COPPERSTRING EIS

Attachment F - Vegetation Clearing Works plans

Dajarra Road to Mount Isa

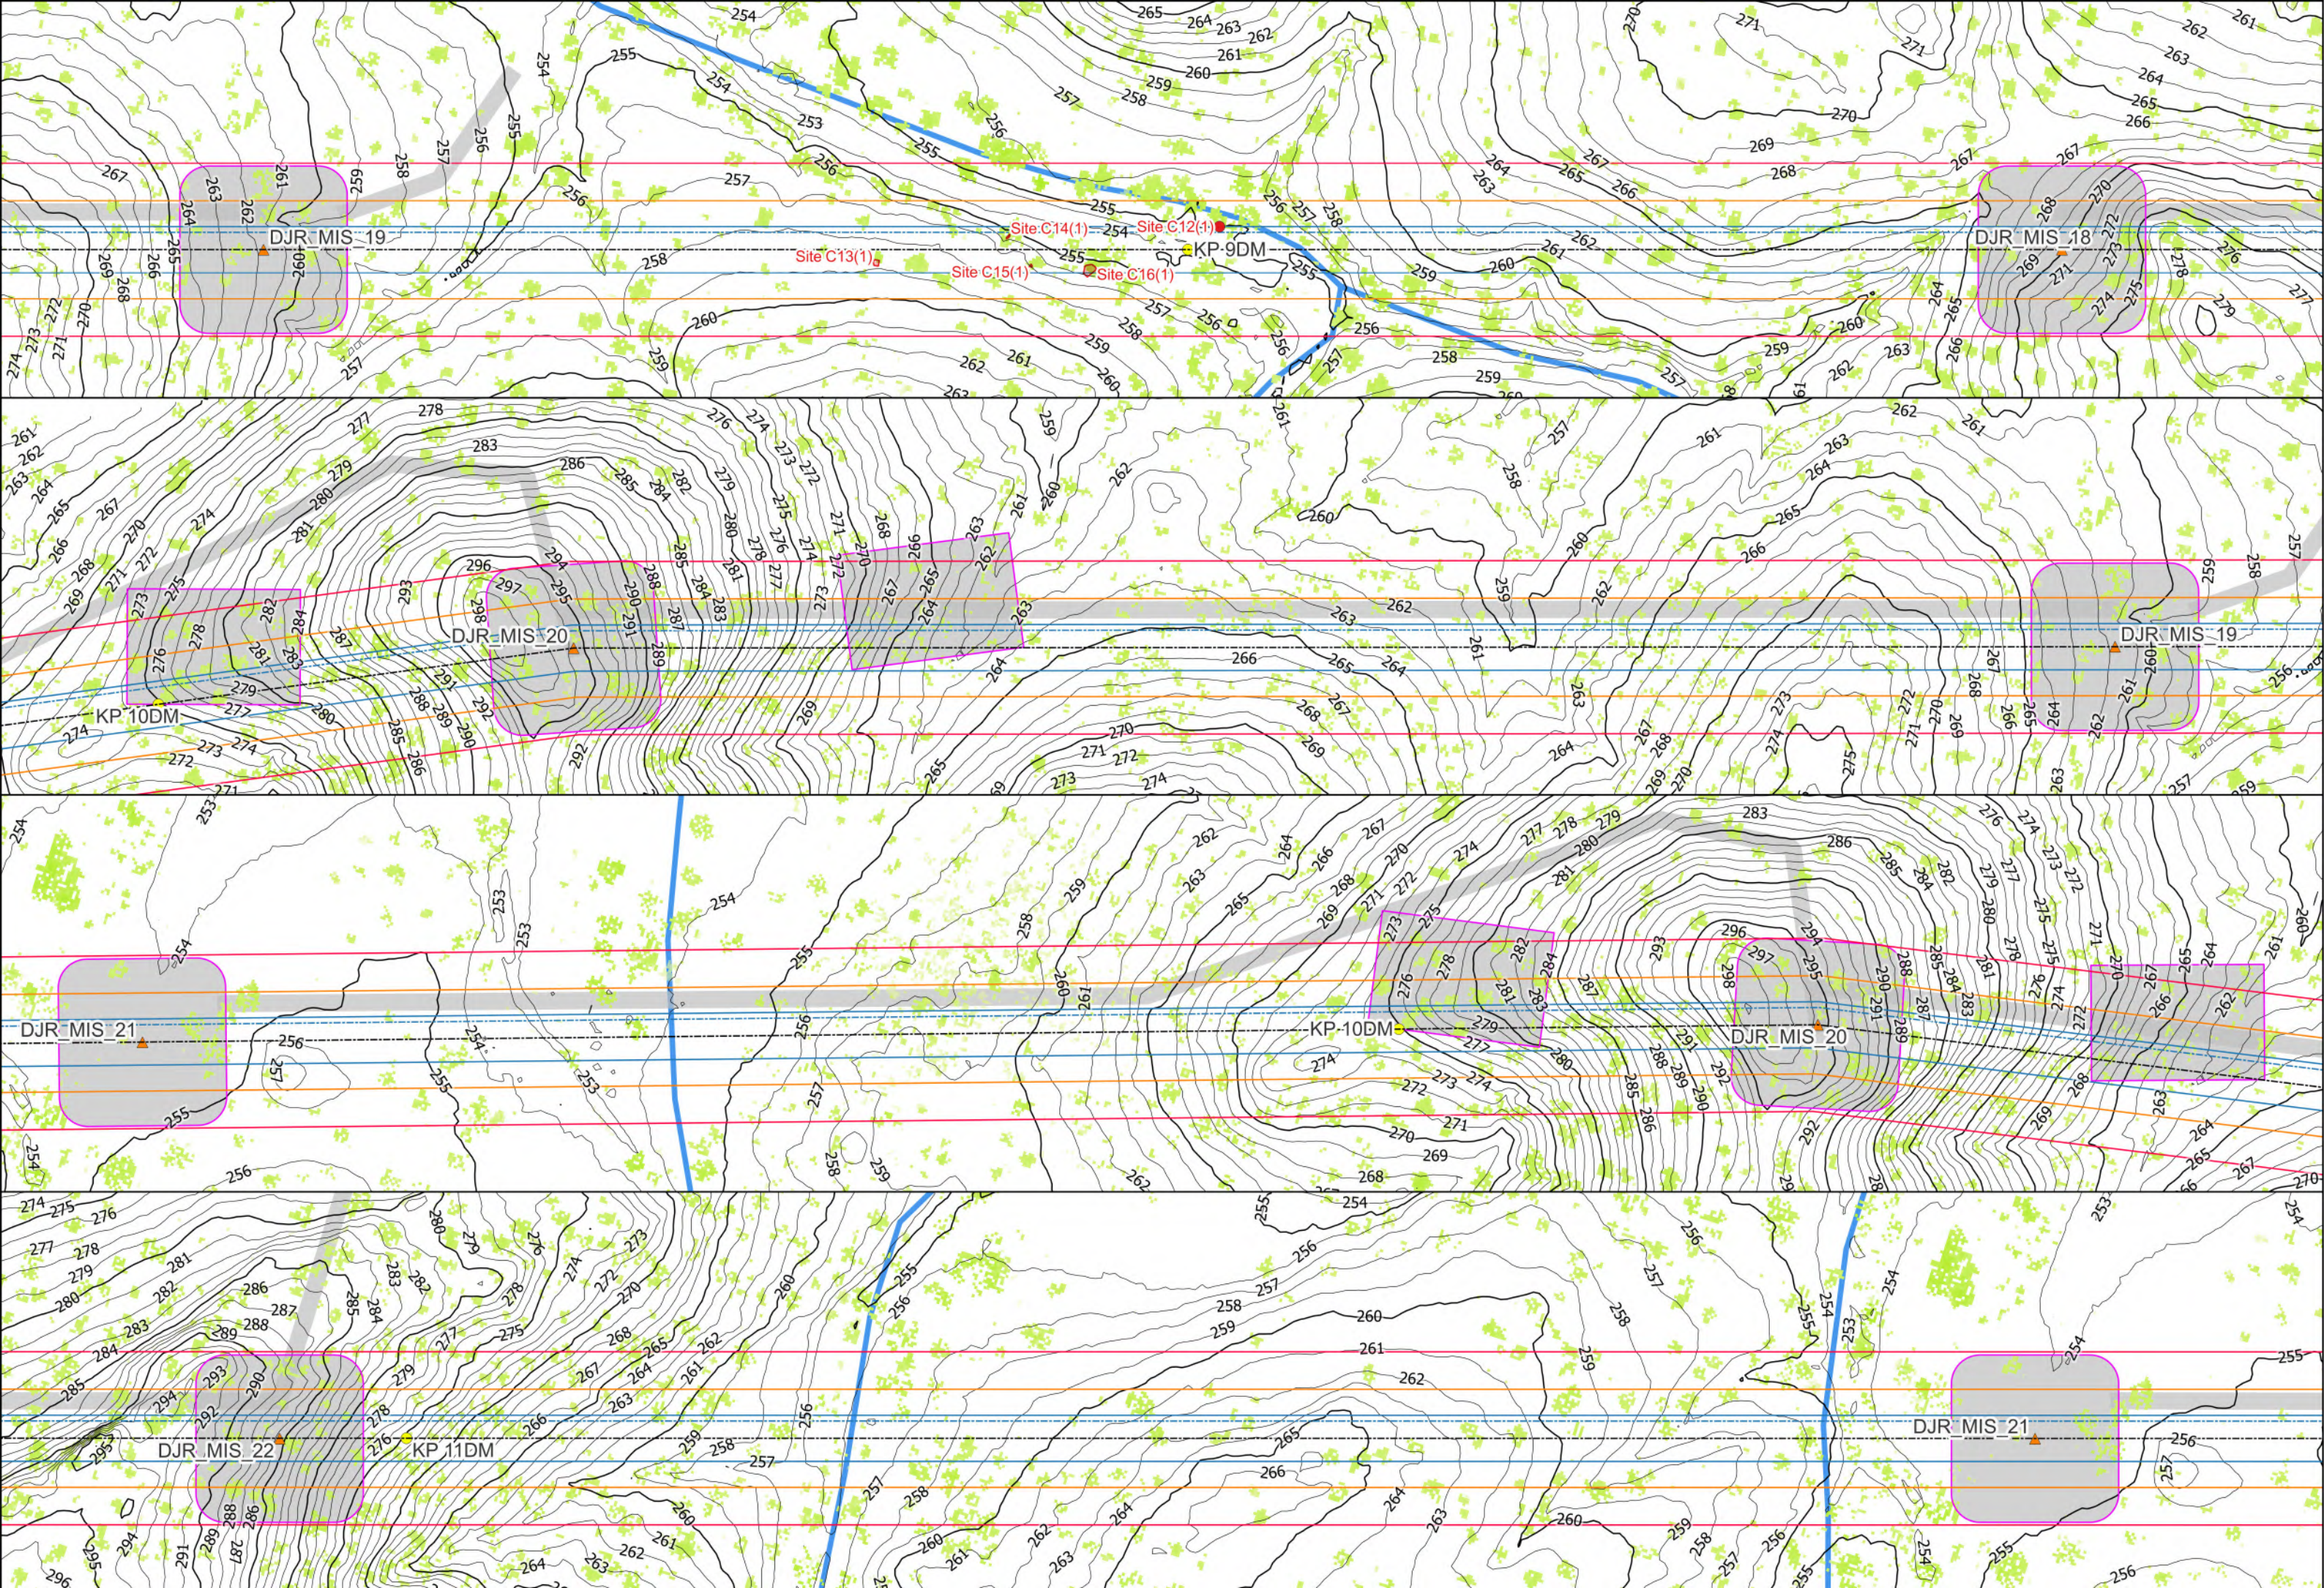
Tower assembly area to be reconfigured to not be within 15m of the high bank of waterway and to avoid clearing near or within the bed and banks for the waterway.

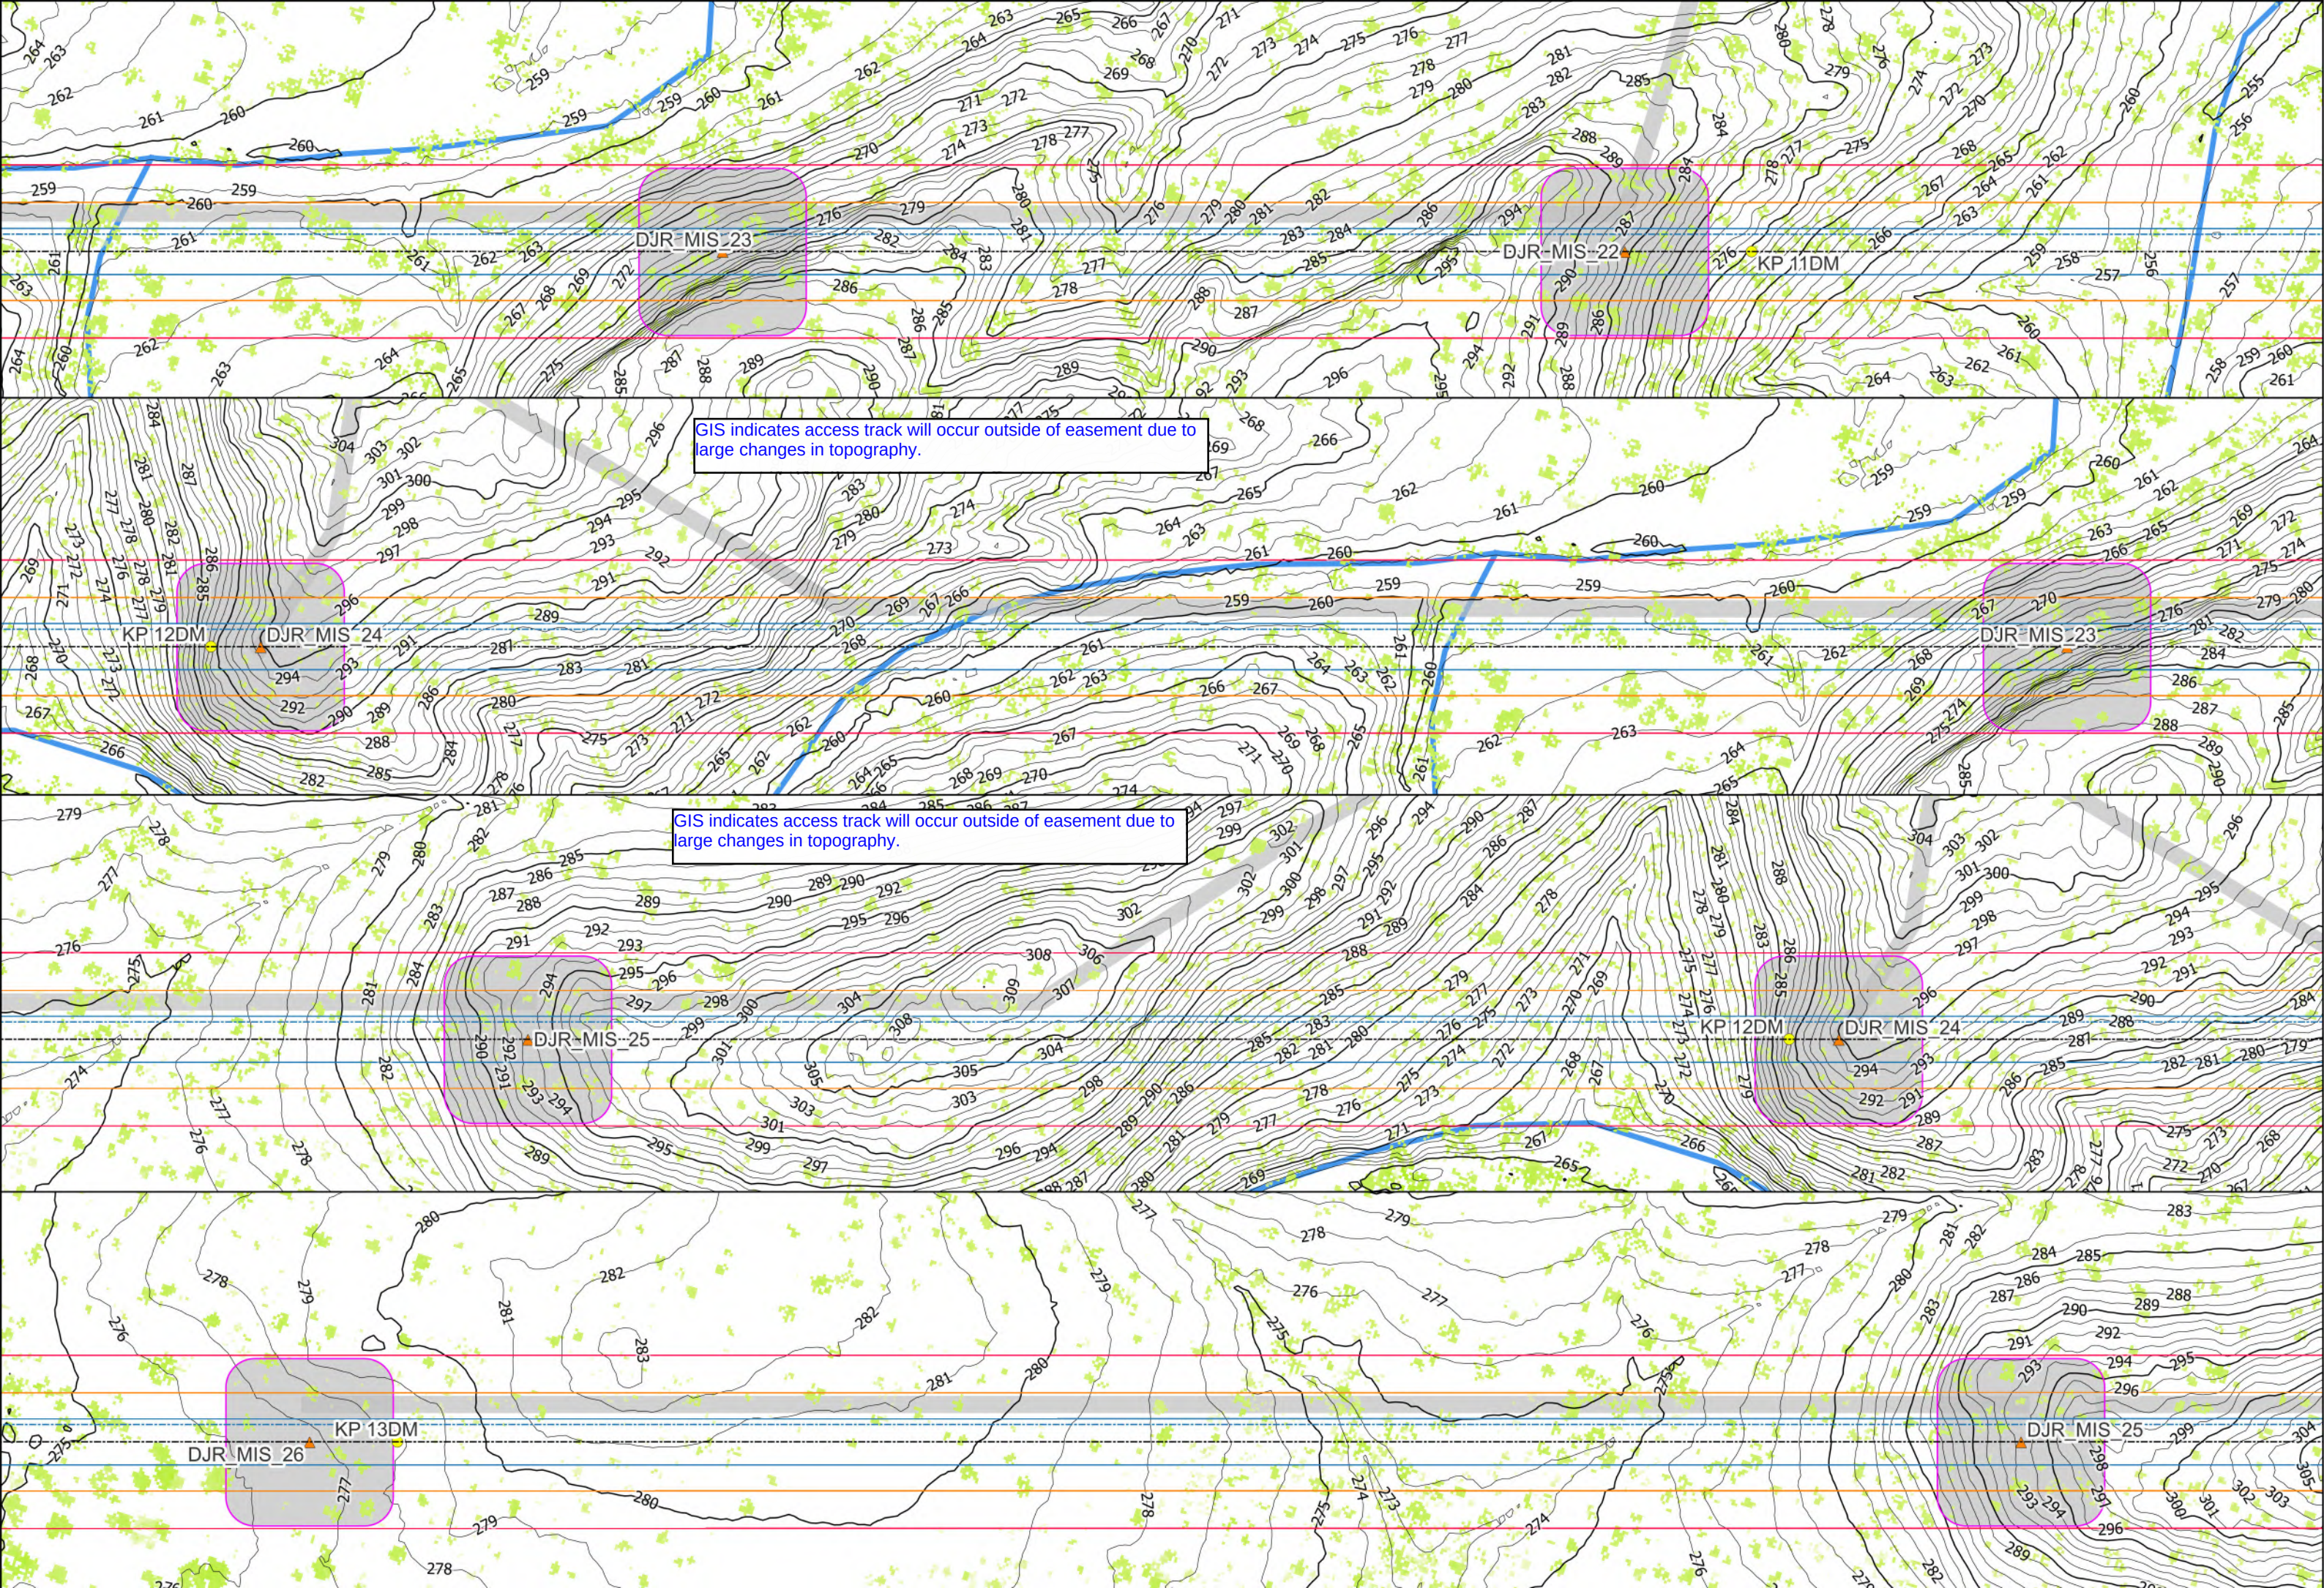
GIS indicates access track will occur outside of easement due to large changes in topography.
